Sirsi Marina Overland Flow Study

Prepared for Essex Develop

October 2023
Project Number S22042

6. Response to Council comments

Figure 9 Proposed Council Pipe Diversion

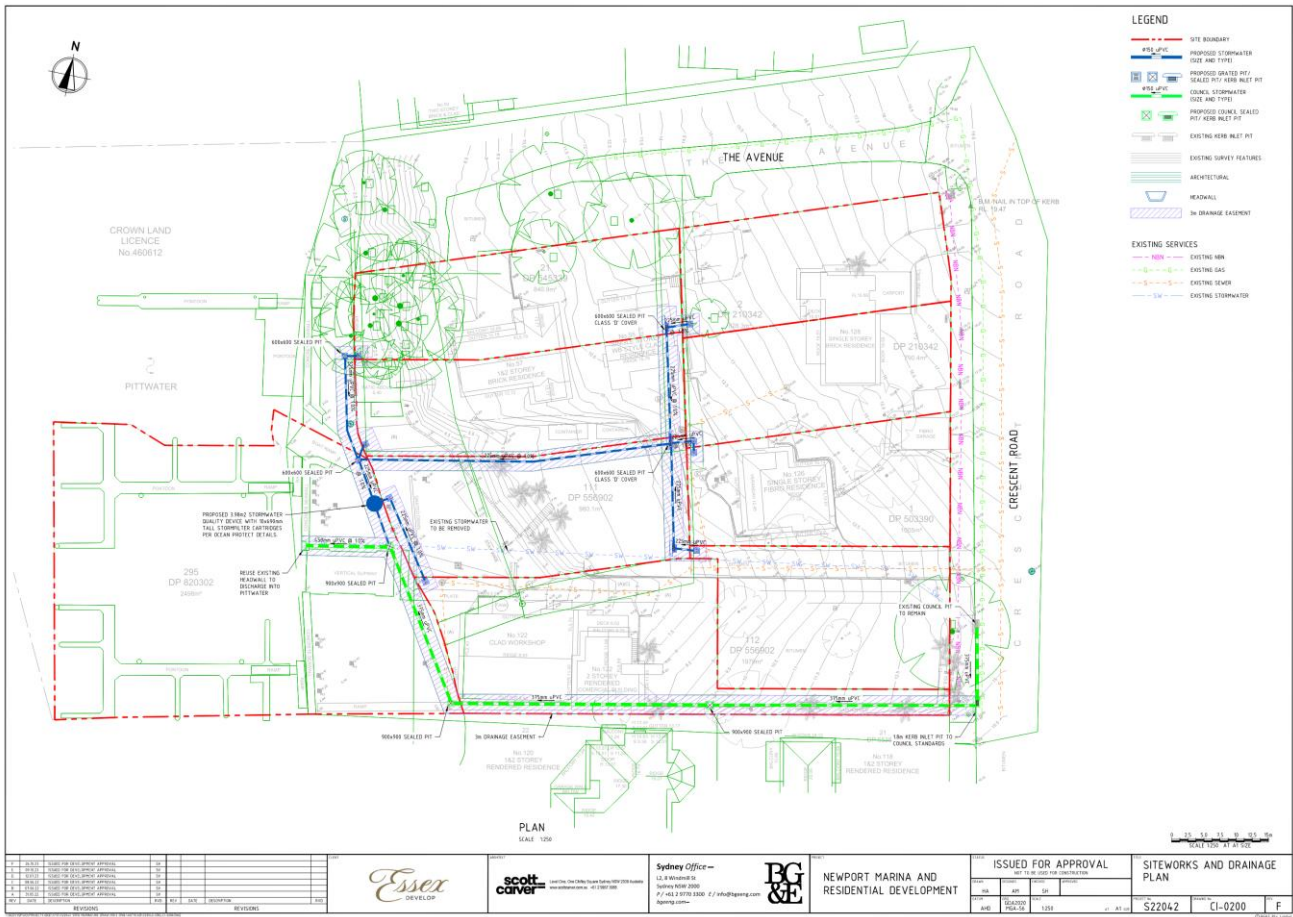
- It is noted that the design engineers BG&E propose to re divert Councils existing 375mm RCP stormwater (SW) line which runs through the current site to the southern boundary with a 3m wide stormwater drainage easement over the re diverted drainage line. This proposal is supported by Councils stormwater assets team.

- The re diverted Council stormwater line running through the site is to be upgraded to have a minimum hydraulic capacity of 5/100 AEP. Flows in excess of this event are to be controlled via an above overland flow path to the 1 /100 AEP.

The proposed development aims to reroute an existing council stormwater 375mm diameter pipe around the site and eventually discharge through the existing headwall at Pittwater Waterway to the site's west. The site lacks any natural water courses, and the existing seawall is expected to remain in good, non-degraded condition for the purpose of re-use. Refer figure 9 for the proposed Council pipe diversion adjacent to the southern boundary of the subject site. A new kerb inlet pit is proposed south of the existing kerb pit along Crescent Road, which will form part of the pipe diversion network.

The DRAINS modelling shown in section 5.3 indicates that the current pipe division is adequate to meet council's requirements. The modelling also showed that the pipe sizing, being council's minimum size, would also cater for the 1% AEP event being 50% blocked.

Figure 10 Close up of the Proposed Overland Flow path and Stormwater Diversion

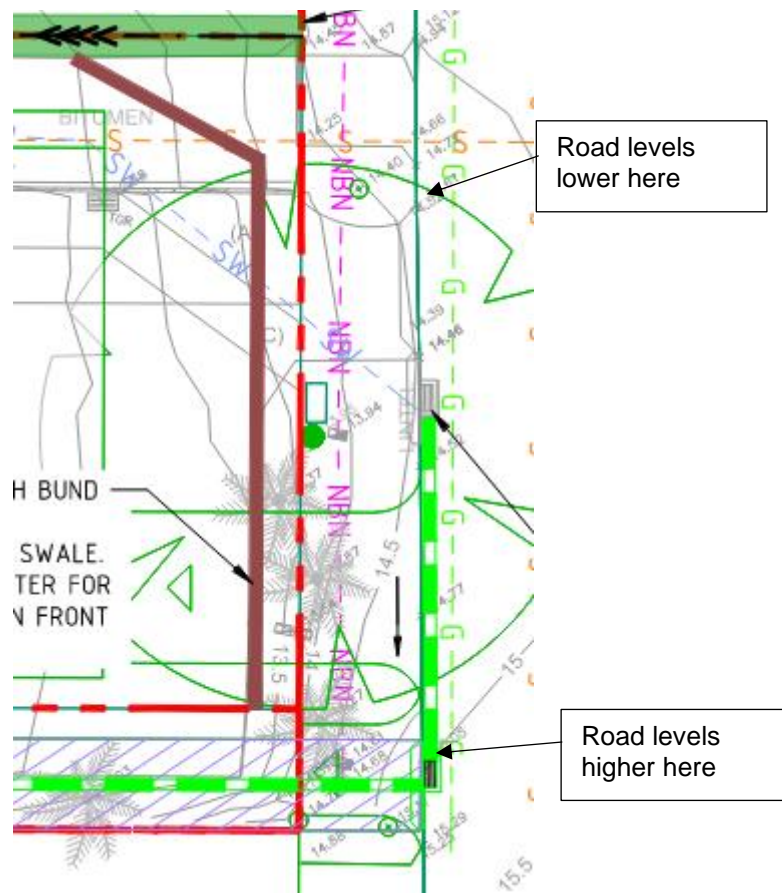
- The current proposed location of the overland flow swale is not acceptable as the overland flow path needs to be aligned with the sag pit Crescent road ie the lowest point . Any overland flow originating from this location cannot physical enter the proposed swale given its separation from the current sag point. Any over land flow path should be aligned from the current sag point in the Crescent Road and follow the alignment of the proposed re diverted Council SW line to the discharge point.

- The overland flow path is to be contained with a widened 3m easement from the sag point in Crescent Road to the outlet.
 - The study is to also review velocity depth ratio in relation to pedestrian safety.

To manage the overland flow, a proposed grassed swales along the boundaries of the subdivision lots 3-4 & 5-6. The current route is proposed as the existing site falls in this direction from the council sag pit, as shown in the survey. This also does not clash with any of the proposed driveways in future housing developments. A bund is to be installed as part of the subdivision works until the property is developed, at which time the bund needs to be made permanent, or a wall to direct the stormwater is to be installed. This is in line with the location for the existing start of the overland flow path and will result in the smallest impact no any ponding in the roadway. See Figure 10 for the proposed layout on top of the existing survey.

If the overland flow path were to be placed in the same location as the proposed stormwater pipe, this would require the stormwater to pond to a level of RL14.7, which is more than 100mm higher than the existing and proposed overland flow route.

The Council's Water Management for Development Policy states that the width of any easement for overland flow is controlled by the minimum practical width necessary for standard machinery to carry out reconstruction of the public drainage system.

Council Comment	BG&E Reply
<p>1. The site is affected by overland stormwater flows in larger storm events predominately along the line the of the existing Council 375mm Concrete stormwater line which runs from the sag point in Crescent Road to the existing seawall . An overland stormwater flow study is to be prepared by a NER/RPENG qualified civil engineer to determine the extent of the overland flow path and impacts on the development including the proposed construction of dwellings. The study is to be prepared by a suitable computer hydrological/hydraulic model. Councils preferred model is DRAINS. The overland flow cross-sections are to be determined by the HEC Ras programme or similar.</p> <p>a. It is noted that the design engineers BG&E propose to re divert Councils existing 375mm RCP stormwater (SW) line which runs through the current site to the southern boundary with a 3m wide stormwater drainage easement over the re diverted drainage line. This proposal is supported by Councils stormwater assets team.</p> <p>b. The current proposed location of the overland flow swale is not acceptable as the overland flow path needs to be aligned with the sag pit Crescent road ie the lowest point . Any overland flow originating from this location cannot physical enter the proposed swale given its separation from the current sag point. Any over land flow path should be aligned from the current sag point in the Crescent Road and follow the alignment of the proposed re diverted Council SW line to the discharge point.</p>	<p>1.a. BG&E accepts that council accepts the location of the stormwater pipe diversion and as shown in this report meets council's standards.</p> <p>1.b. The location of the overland flow path is the best location on the site due to the following discussed in this report:</p> <ul style="list-style-type: none"> • Location due to low point on site and inline with where the existing overland flow path is. <ul style="list-style-type: none"> ○ Moving the overland flow to the same location as the stormwater pipe diversion will force stormwater uphill and cause a large amount of ponding in the roadway • Can achieve a safe flow route <ul style="list-style-type: none"> ○ No Major structures in the flow path ○ No Pedestrian access ○ No Vehicle access ○ No impact on the future driveway • The overland flow is proposed to flow by a bund into the proposed swales in the temporary case and in the premiant case can be a wall or bund to control the direction of flow. <p>Council's request that the overland flow and stormwater diversion align does not work for this site due to the existing road levels. Refer to section 4.4 of this report.</p>
